Date: November 30, 2023
To: All Vendors
Subject: Addendum #2

**REFERENCE: B014-24 Re-Bid BPUB Downtown Wastewater Improvements-ARPA
Project 1**

Project:	Brownsville PUB – Downtown Wastewater Improvements ARPA Project 1 BPUB Bid No. B014-24	Addendum Date:	November 30, 2023
From:	Javier A. Esquivel, PE	Project No.:	BPUB2200025.01

ADDENDUM No. 2

CC05

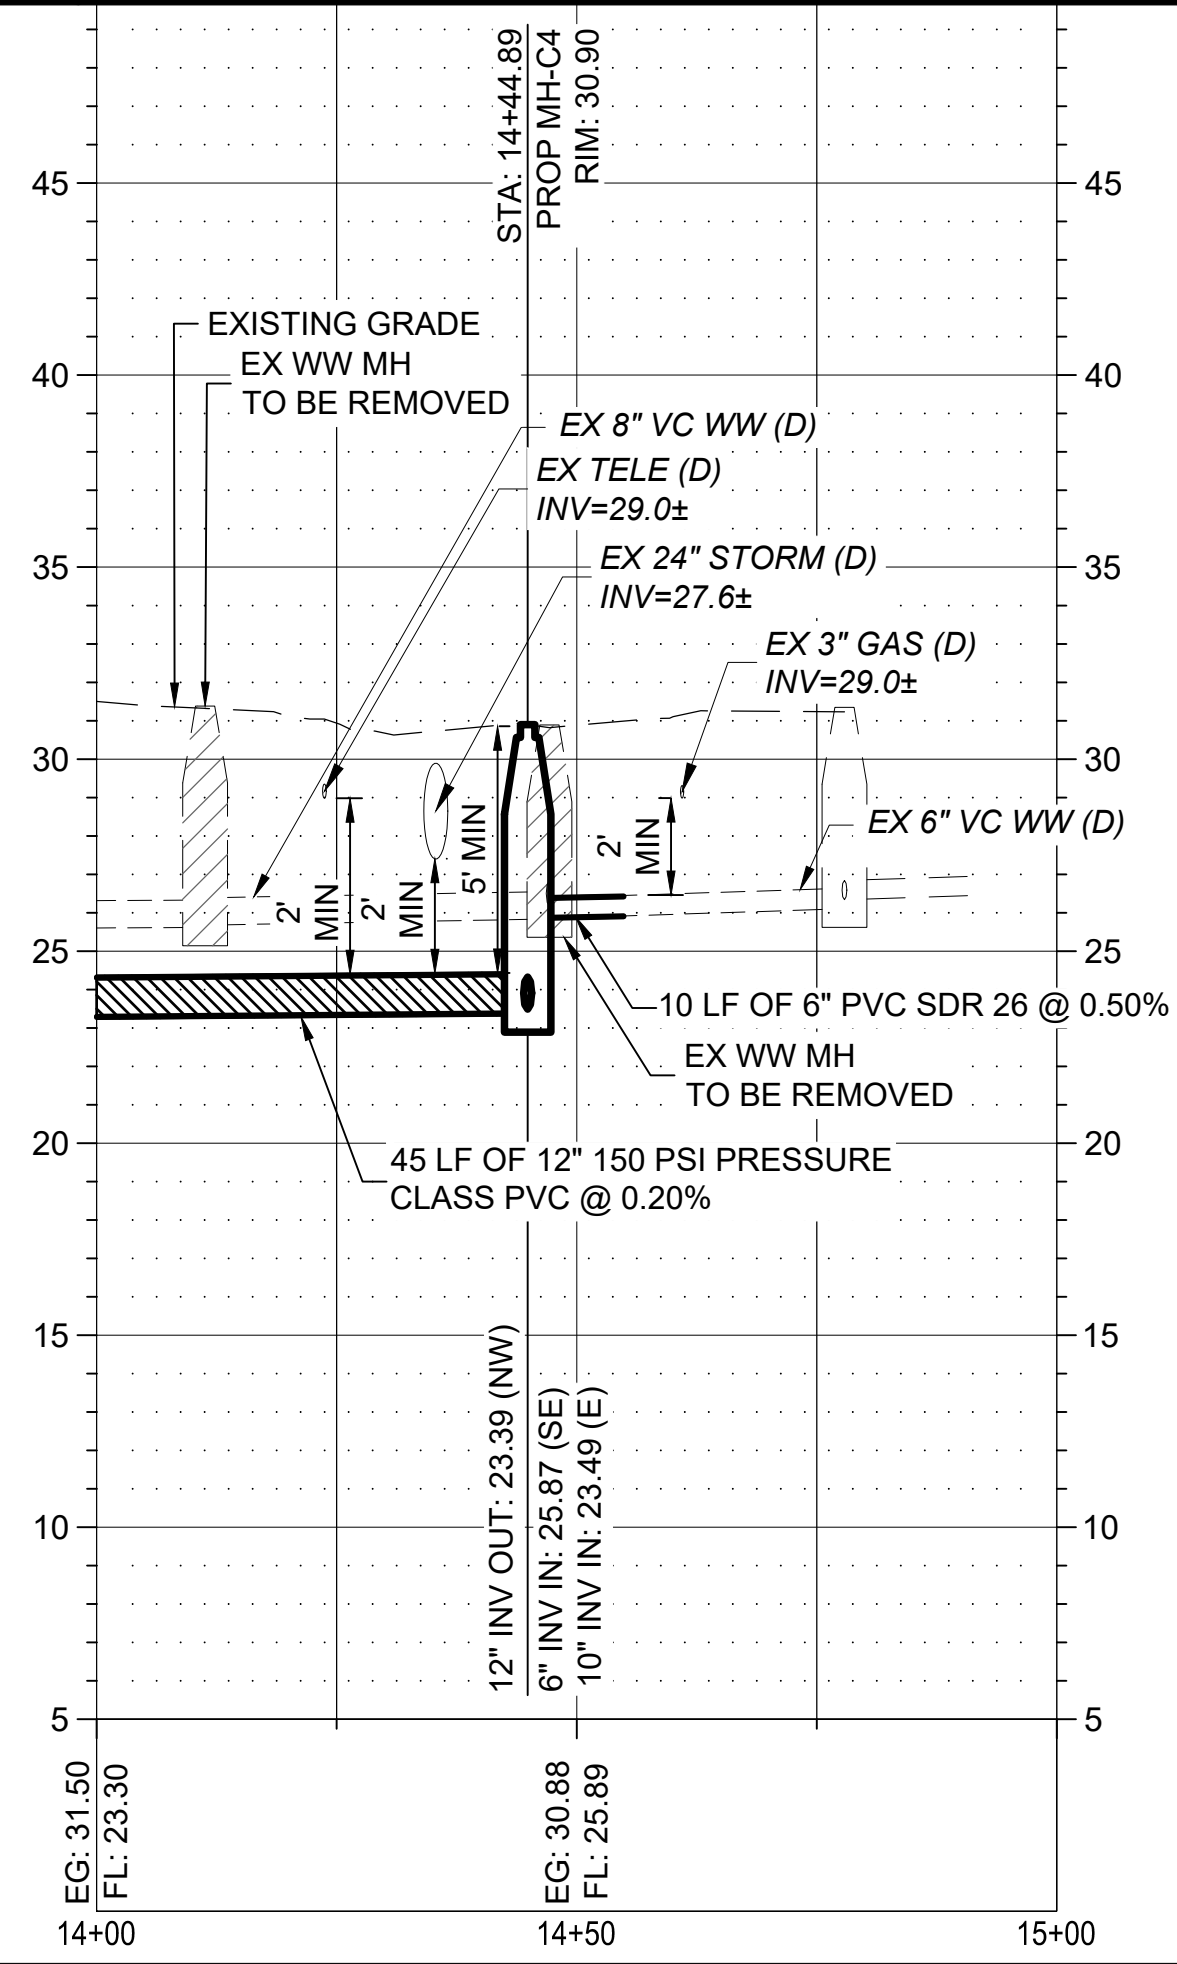
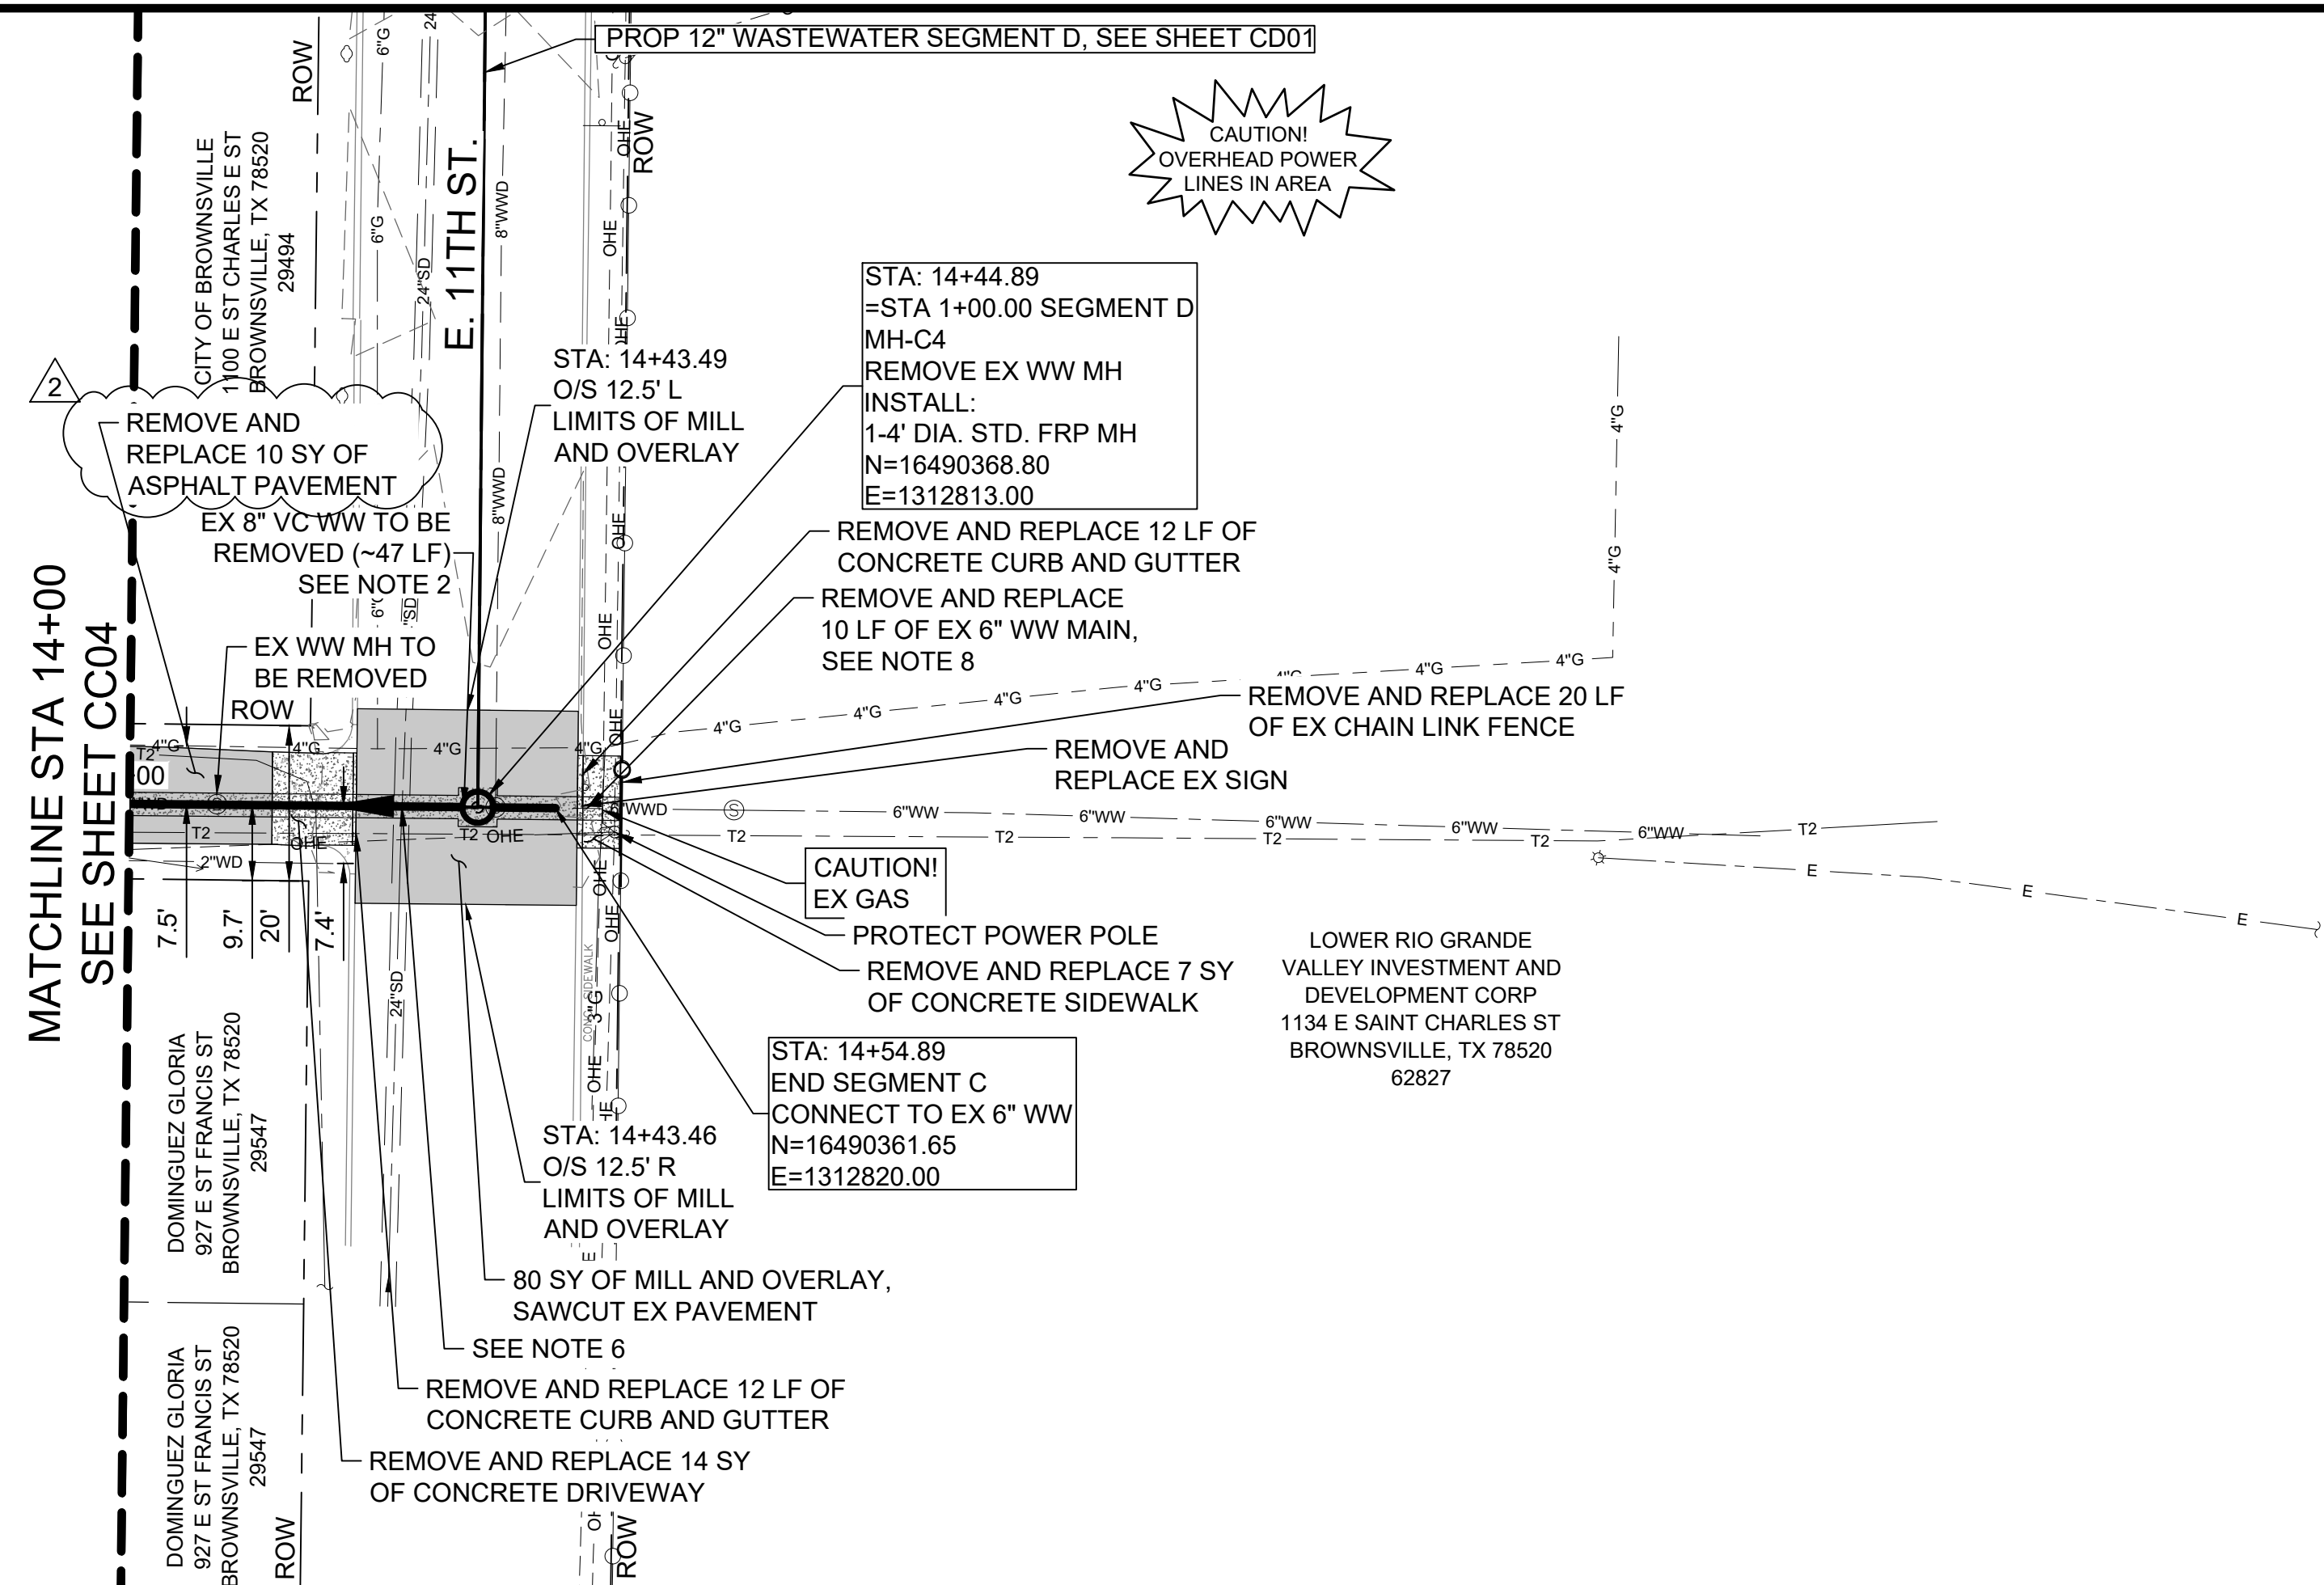
1. Revisions to Surface Restoration in the Alleys.
 - Segment A: Replace Mill and Overlay (2”) with full depth concrete asphalt pavement removal and replacement.
 - Segment B: Replace Mill and Overlay (2”) with full depth asphalt pavement removal and replacement.
 - Segment C: Replace Mill and Overlay (2”) with full depth asphalt pavement removal and replacement.

3. Plan Sheets: The following plan sheets were modified to update surface restorations CA02, CA03, CA04, CA05, CA06, CA07, CB01, CB02, CB03, CC02, CC03, CC04, and CC05.
